Service Bulletin

Reference #050

Glasstech Upper DB4 Automotive "Jumping Jack" Quench; Attachment to Support Super-Structure

New Design (below)

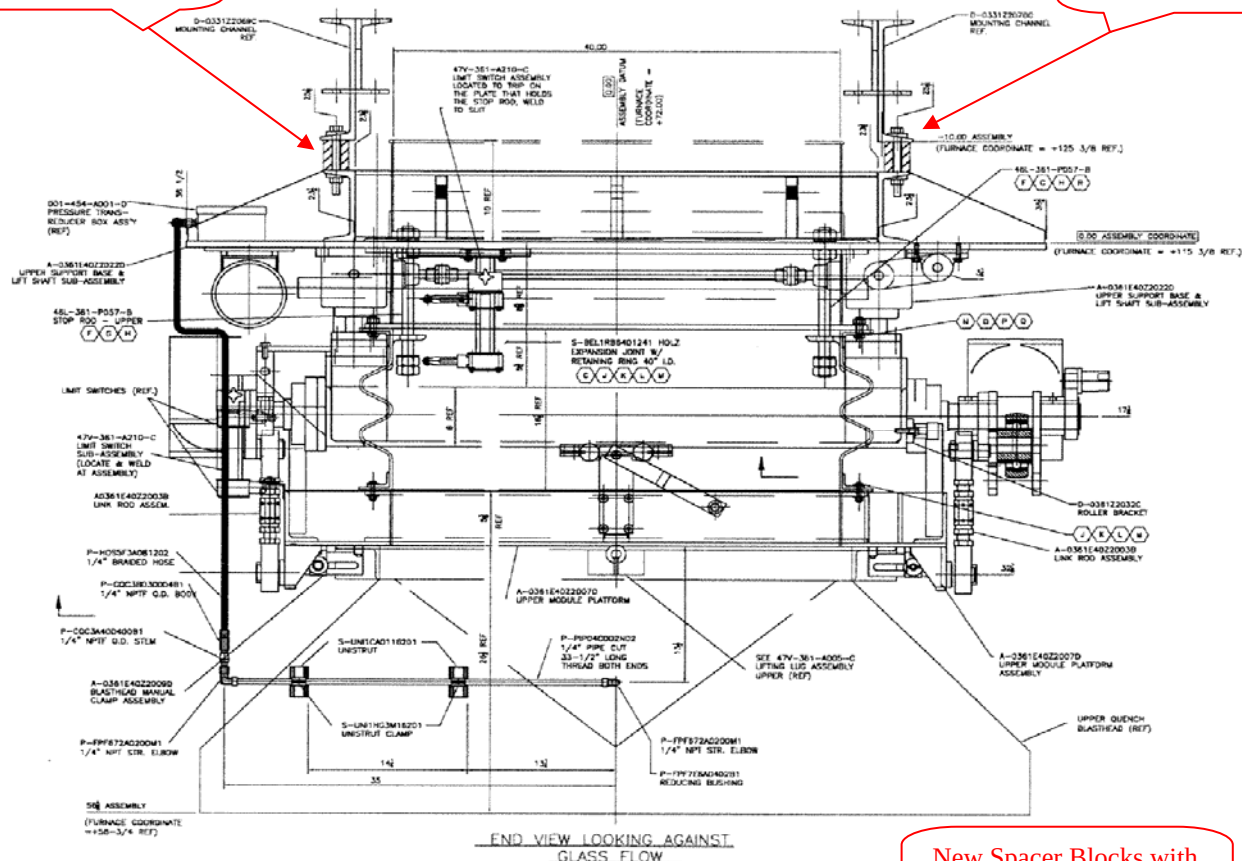
The upper DB4 automotive quench system assembly Glasstech P/N **A-0361E40Z2007D** is subject to a possible failure of the mounting hardware (treaded rods) used to secure the assembly to the superstructure above it. The original design utilizes a quantity of ten (10) 5/8 inch-11 x 8 inch long hardened rods with hex nuts and washers. Glasstech has reviewed the design following a reported field failure and determined that an alternate enhanced fastening system should be promptly implemented. Glasstech will provide both detailed prints and parts lists (below) and will also be shipping the required parts to the respective job site for immediate installation. **Glasstech recommends that you immediately inspect your system and implement this corrective action to avoid possible equipment damage and/or personal injury.**

New Spacer Blocks with new bolts
